CITY OF PUYALLUP

January 12, 2021

FINAL DEVELOPMENT REVIEW TEAM (DRT) LETTER	
PERMIT #	P-20-0085
PROJECT NAME	Andrey's Estates Preliminary Major Plat
PERMIT TYPE	Preliminary Major Plat & SEPA
PROJECT DESCRIPTION	Proposed preliminary major plat subdivision of 3.26 acres into seven (7) residential lots in the RS-06 zone. The proposed preliminary plat includes public roadway extensions, four (4) private tracts (for various purposes including critical areas protection, open space, parking, access), extension of utilities, dedication of public right of way, walking pathways, street improvements and landscaping.
SITE ADDRESS AND PARCEL #	2617 9 th St SW - TPN 0419041029
ASSOCIATED LAND USE PERMIT(S)	P-20-0013 (pre-app)
APPLICATION DATE	August 21, 2020
APPLICATION COMPLETE DATE	August 26, 2020
PROJECT STATUS	<u>Final Development Review Team (DRT) letter.</u> The latest revised copy of submitted materials has fulfilled the city's requirements related to the land use permit in accordance with the following conditions and notes. The project is now proceeding into final SEPA review and issuance, followed by the scheduling of a public hearing on the project.

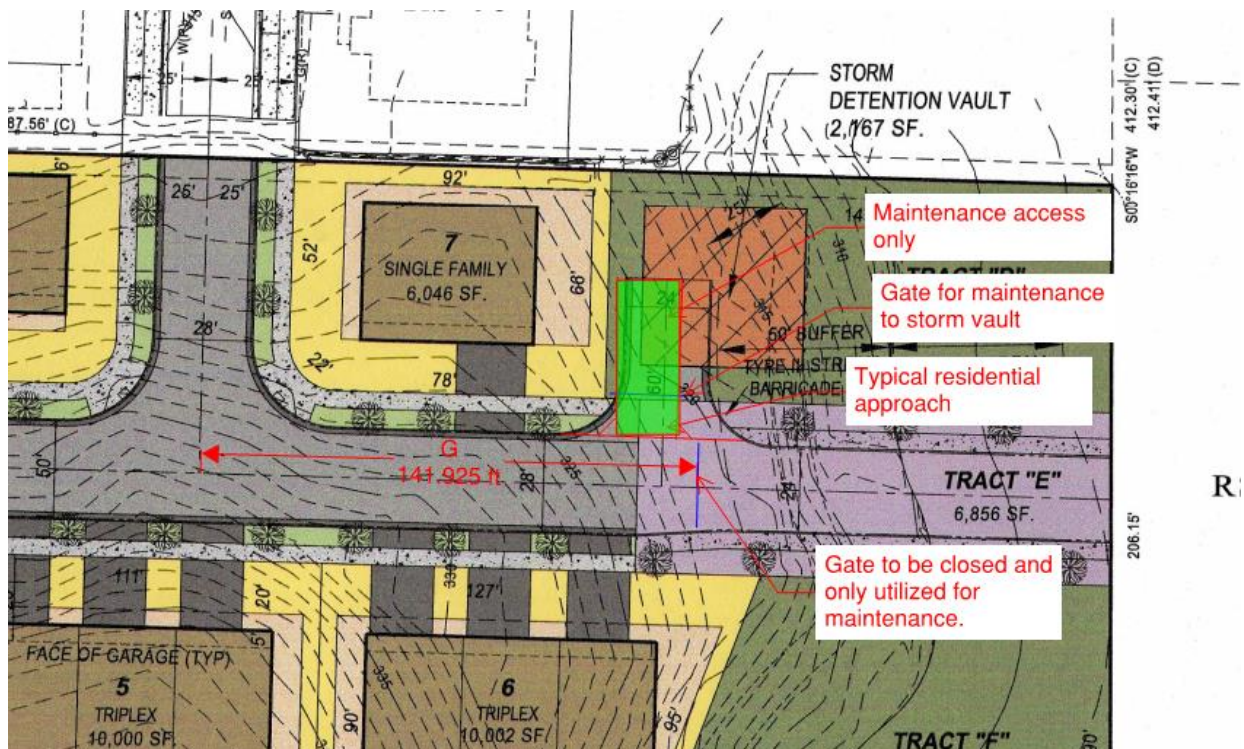
1. Address and resolve Engineering comments and notes related to needed amendments to the plat drawing, including survey submittal requirements, amendments to tracts shown and needed easements. These changes need to be made prior the Plat hearing.

1. Provide a complete Survey of the Plat that contains all the items outlined in (2) of the Requirements for Submittal of a Preliminary Major Plat.
2. Revise the Plat to include Tract E as dedicated Right of Way of 50'. See planning note #2.

3. Show an easement over tract A and B. The easement shall benefit the city for access and maintenance of the storm system.
4. Tract D shall be a private critical area tract that is owned and maintained by the HOA. Provide a storm easement that allows for access and maintenance of the storm system.

5. Tract F shall be a Private Critical Area Tract that is owned and maintained by the HOA.
6. Revise the plat drawing to remove the Fire truck turnaround. The maintenance access to the storm vault on Tract D shall be a standard no radius type driveway approach (residential approach detail). A Gate shall be installed at the access to the storm tract and within the Right of way at 150' max from the T intersection. (SEE Mark up)

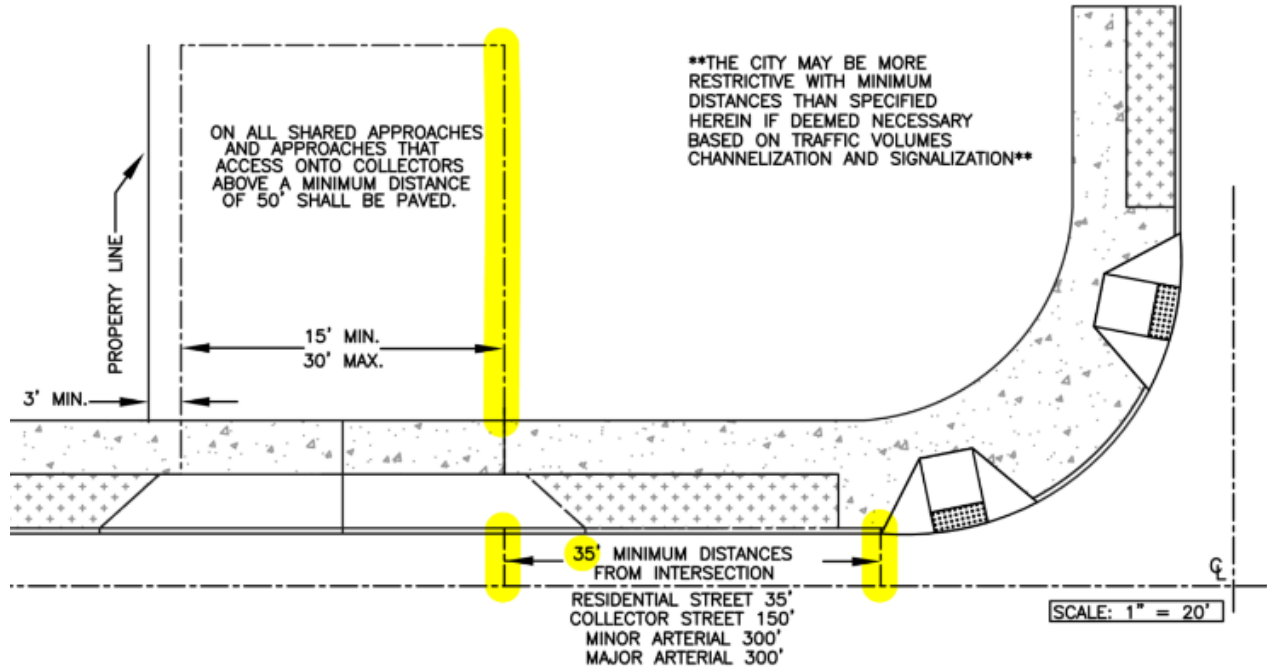
1. Lot 1 driveway (closest edge) must be at least 35ft from the PT of intersection per engineering standards
